**OLIVER RANCH
PUD / POADP PLAN**

Re: Oliver Ranch (Amending)

MDP/POADP # 662-A

POADP NAME: OLIVER RANCH (SUBDIVISION) #662-A

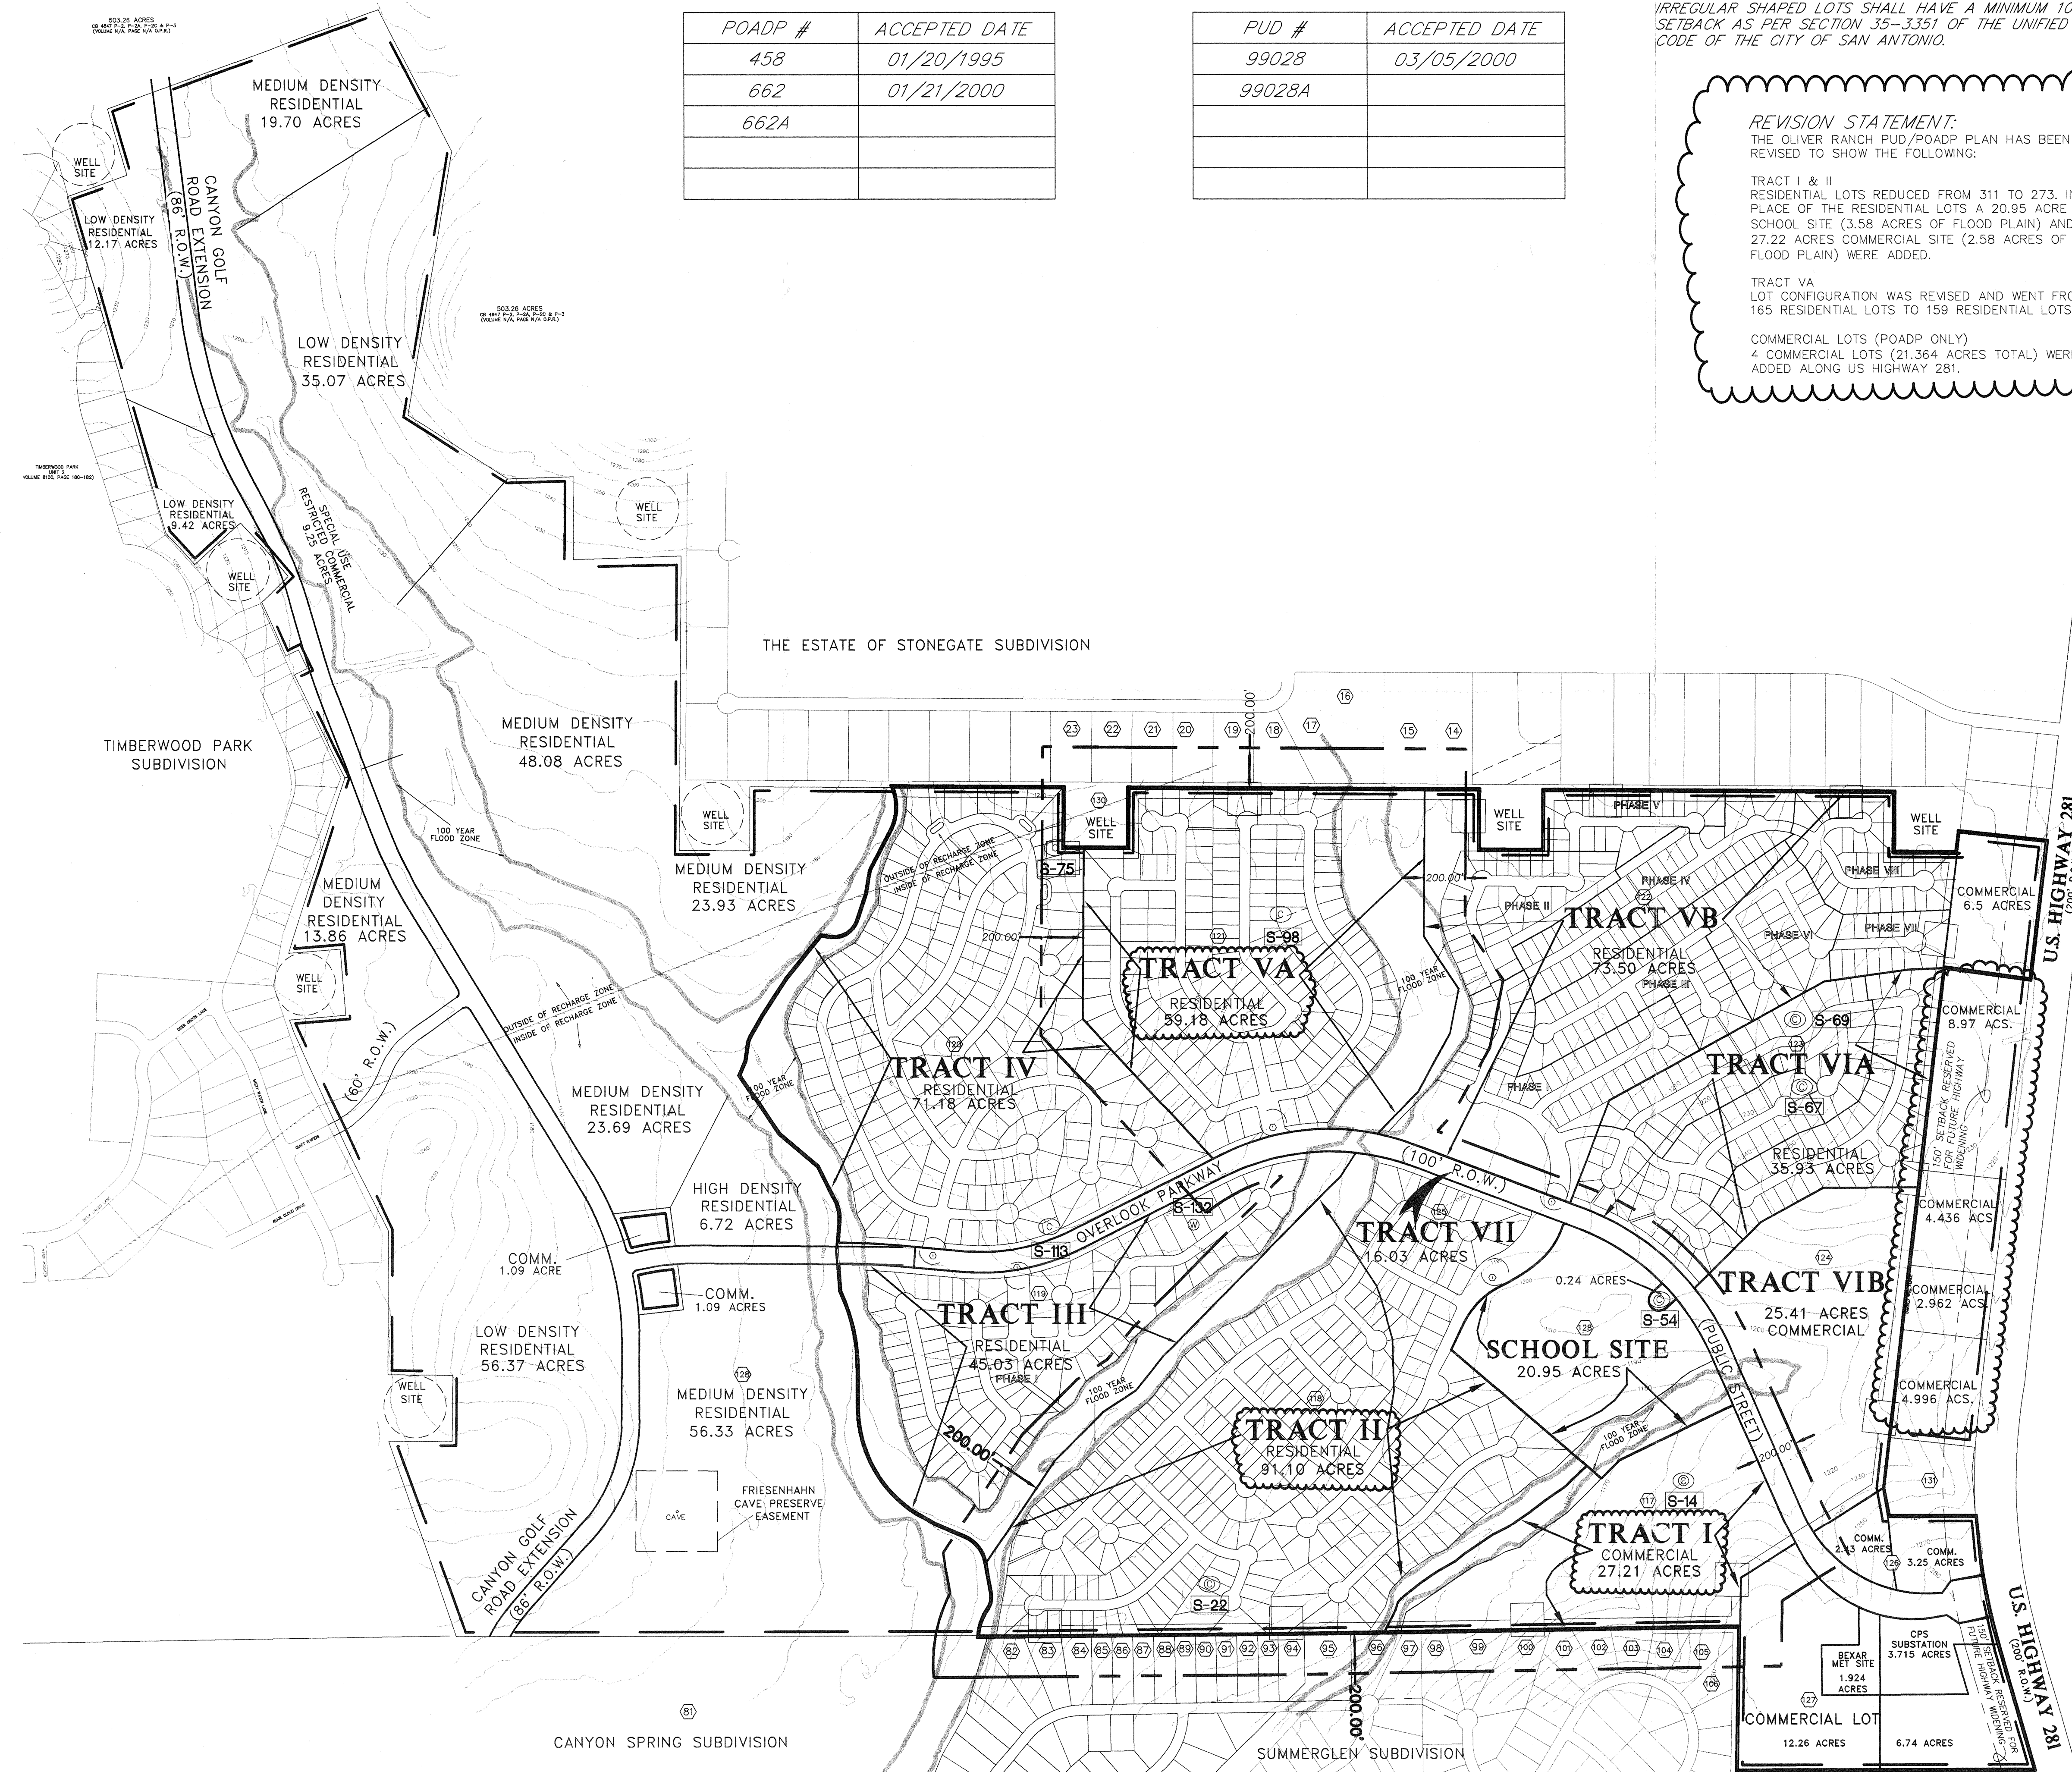
Comments: U.S. 281 IS ON THE MTP AND TxDOT SYSTEM
REQUIRING A MIN. OF 120' ROW AND TxDOT REVIEW.
THIS REVISE MDP DELINEATE AND SHOW THE
PROPOSE EXTENSION OF CANYON COVE ROAD. THE PROPOSED
MDP/PUD DO NOT REFLECT THE MTP ALIGNMENT AND ROW
REQUIREMENT OF THE PROPOSE EXTENSION OF CANYON
ROAD. IT DOES NOT REFLECT THE MTP PROJ. MAP.

Comments: U.S. HIGHWAY 291 IS ON THE MTP AND TXDOT
SYSTEM REQUIRING A MIN. OF 120' ROW AND TXDOT REVIEW.
CANYON CULF ROAD IS ON THE MTP REQUIRING A MIN. OF
86' ROW. 3200005 PLAT REVISION ADDRESS
THOROUGHFARES

Comments: U.S. HIGHWAY 281 IS ON THE MTP AND TXDOT
SYSTEM REQUIRING A MIN. OF 120' ROW AND TXDOT REVIEW.
CANYON GOLF ROAD IS ON THE MTP REQUIRING A MIN. OF
80' ROW. REVISE PROPOSE MDP TO REFLECT THE MTP
ALIGNMENT OF CANYON GOLF ROAD EXTENSION; HOWEVER
REVISE PROPOSE MDP NEED TO DELINEATE THE PROPOSE
CANYON GOLF ROAD EXTENSION AS A SECONDARY
ARTERIAL TYPE A REQUIRING 80' ROW

Comments: U.S. 281 IS ON THE MTP AND TXDOT SYSTEM
REQUIRING A MIN OF 110' ROW AND TXDOT RELEASE.
THE PROPOSE PLD/POADP PLAN DOES NOT REFLECT THE MTP
ALIGNMENT OF GOLF CANYON ROAD/EVANS THOROUGHFARE.

FIGURE 16
COMMERCIAL DRIVEWAY LOCATIONS

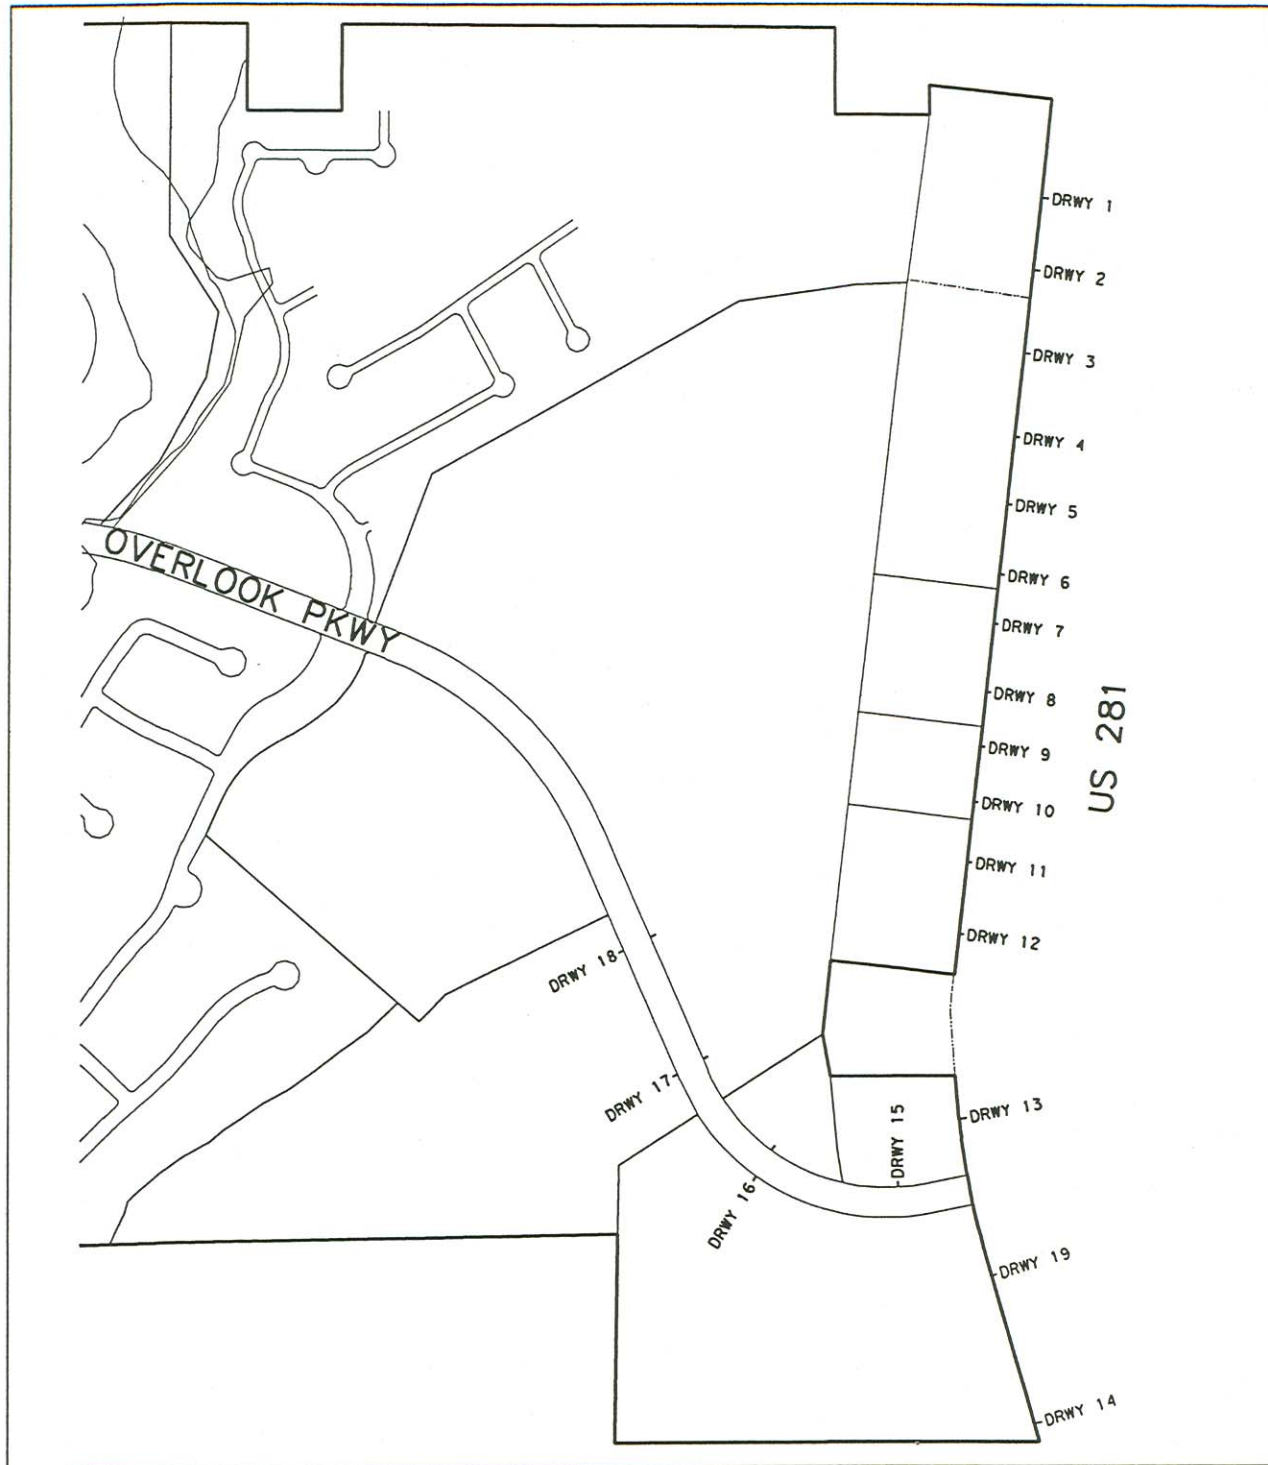
- Construct a signalized intersection at or near the proposed Driveway 18 at least ¼ mile away from the frontage road intersection.
- Construct a signalized intersection at the school's roadway and at least ¼ mile away from Driveway 18.

It should be understood that the submitted TIA is a conceptual plan and therefore this document does not represent an approval for the internal street plan. Reduced number of driveways and common access between the commercial lots are encouraged in order to provide safe and efficient movement of traffic to and from, within and past, the proposed development, while minimizing the impact to non-site trips.
